Friends of the Scarsdale Parks, Inc.
P.O. BOX 53
SCARSDALE, NEW YORK 10583

August 14, 2016

The directors of the Friends of the Scarsdale Parks, Inc. wish to share with you some practical ideas that might provide additional economies in the Library's July 2016 Option A-1 "modifications to landscaping and hardscape plan."¹

PROPOSED PLANT LIST

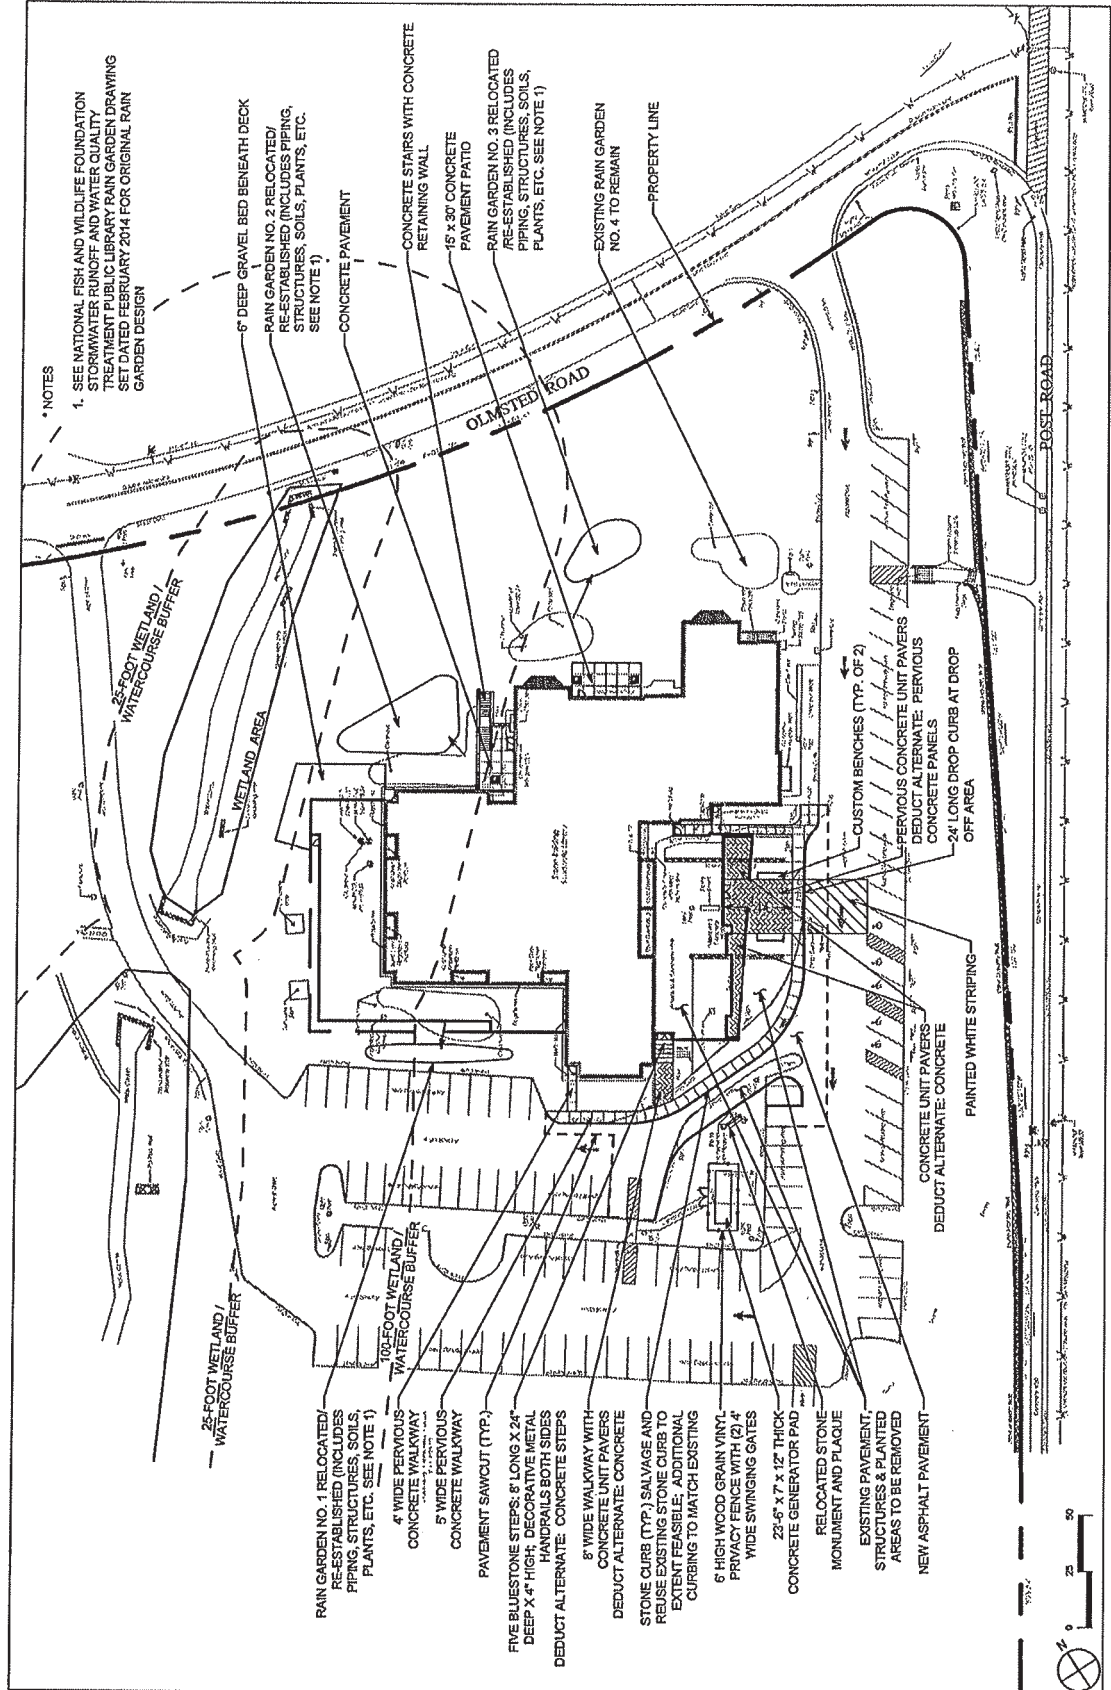
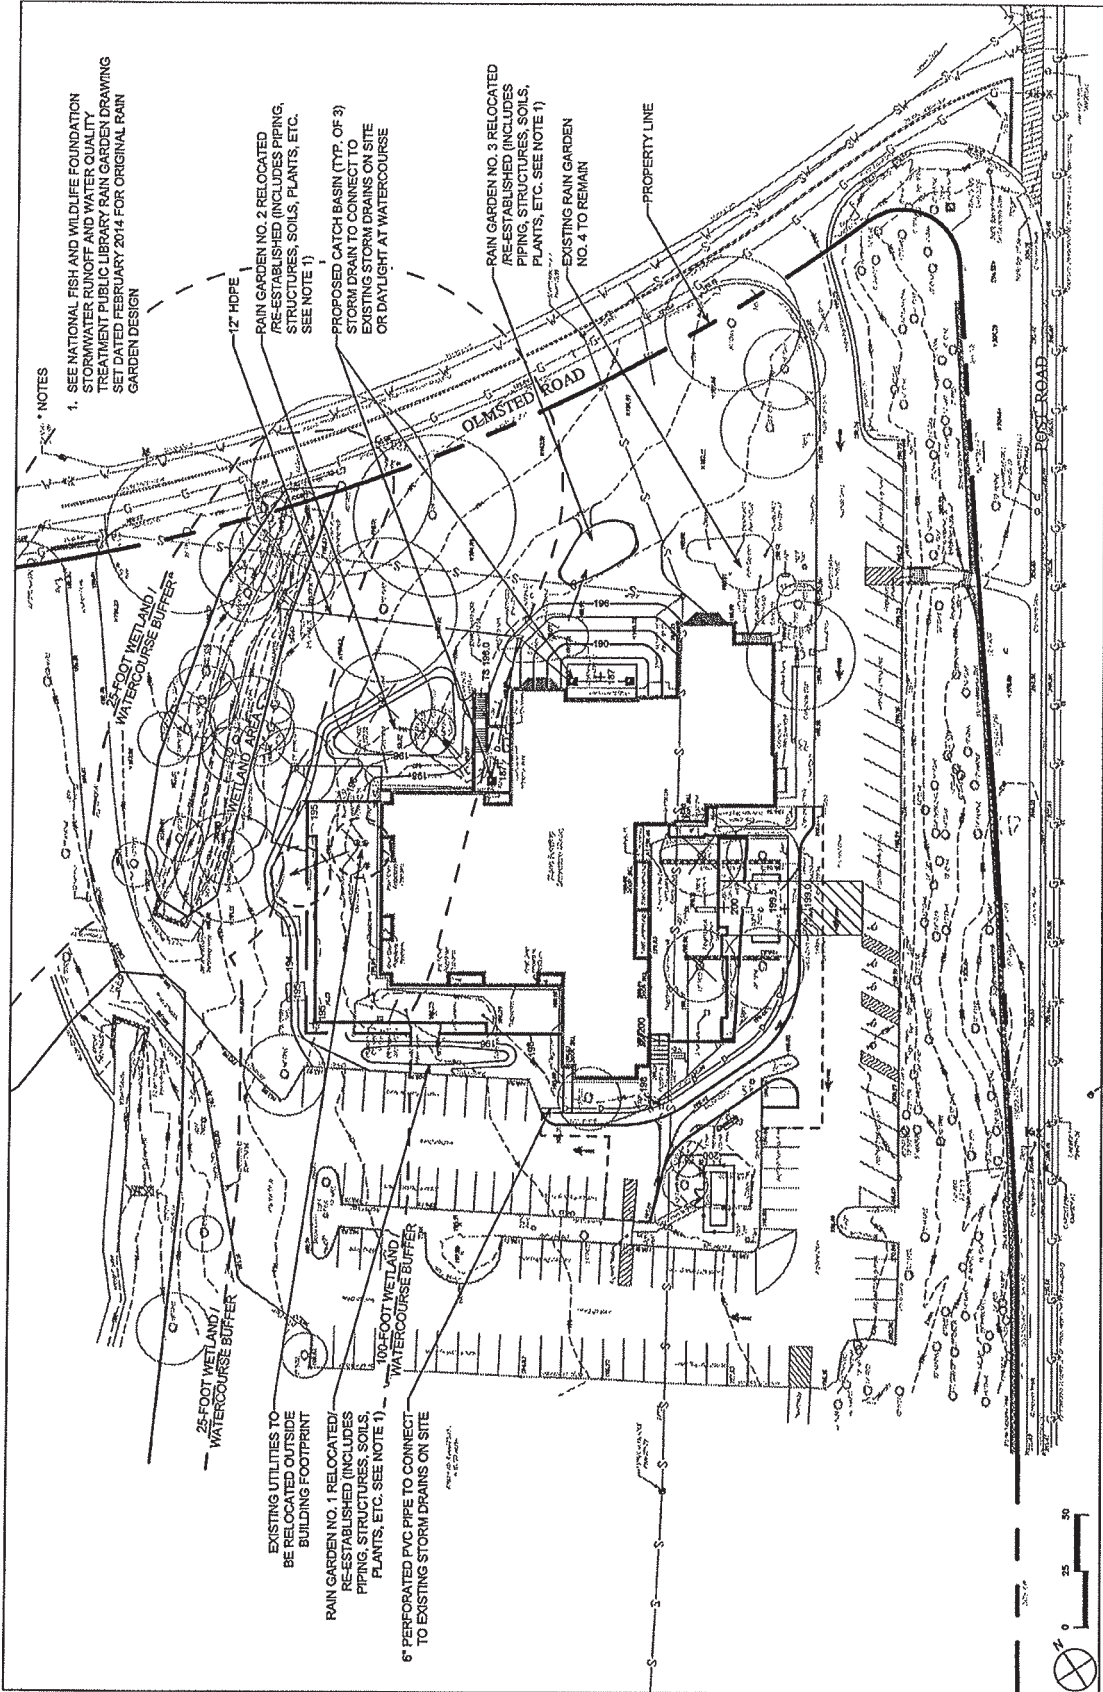
2. Requiring that any new landscaping will comprise only native plants, which would require modification of the Dattner Architects/Divney Tung Schwalbe landscape consultants' Proposed Plant List.³ Dattner/Divney (page 55) calls for a number of non-native plants that are also invasive or otherwise problematic, such as Boxwood, which is currently subject to widespread fungal diseases in the Northeast, and Japanese *Pachysandra terminalis*, which is not only invasive but non-native and can easily be replaced by native groundcovers such as *Pachysandra procumbens* (Allegheny spurge);

5. Identifying the 6 trees designated for removal in the Dattner/Toscano Clements Taylor consultant's cost estimates, which appears for the first time in the 148 page report on page 108.⁴ Assuming the 2 additional trees slated for "arborist evaluation" are (2 of the 4) Locust trees closest to the building on the entry plaza, the other 6 trees and their location should be identified. Consideration should be given to preserving not only these trees but also the valuable ornamental evergreens and deciduous trees on the south side of the building, many of which were donated by a resident who curated these unique specimens;

6. Rectifying the omission of equivalent replacement trees. Inexplicably, the Dattner/Toscano cost estimate (page 108) does not include the 3-3 ½" caliper Sweetgum listed on the Dattner/Divney Proposed Plant List (page 55), nor any other deciduous canopy tree to replace the 8 trees proposed for removal (at a labor cost for removal of almost \$3,000);

7. Similarly, the Dattner/Toscano cost estimate (page 108) lists only one, not 2 understory Redbud trees as originally proposed (Dattner/Divney plant list, page 55), at an exorbitant cost of \$850 for just one tree. Redbuds are relatively short-lived small trees that need sufficient sunlight. A better ecological choice of an understory tree to support birds and pollinators, and to provide attractive spring blooms is the Hawthorn;
